SUBJECT : Hyundai ImageQuest Co., Ltd.
FCC ID: PJIL17A0D080
Class II Permissive Change
Orig. Grant Date: March 12, 2003

Transmitted herewith, on behalf of Hyundai ImageQuest Co., Ltd. is an application for a Class II Permissive Change Certification of the following 17-inch LCD Monitor:

FCC ID : PJIL17A0D080
Model/Type : L70S/L17A0D080

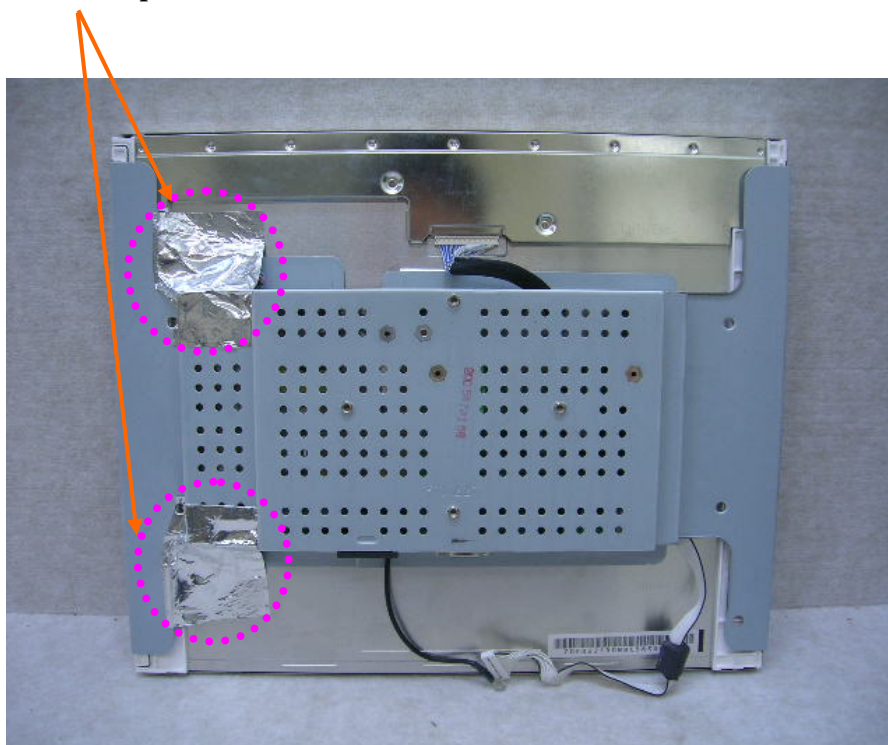
1. Attach aluminum tape on the frame

2. Apply a ferrite core to the OSD Cable

1. Attach aluminum tape on the frame
2. Apply a ferrite core to the OSD Cable
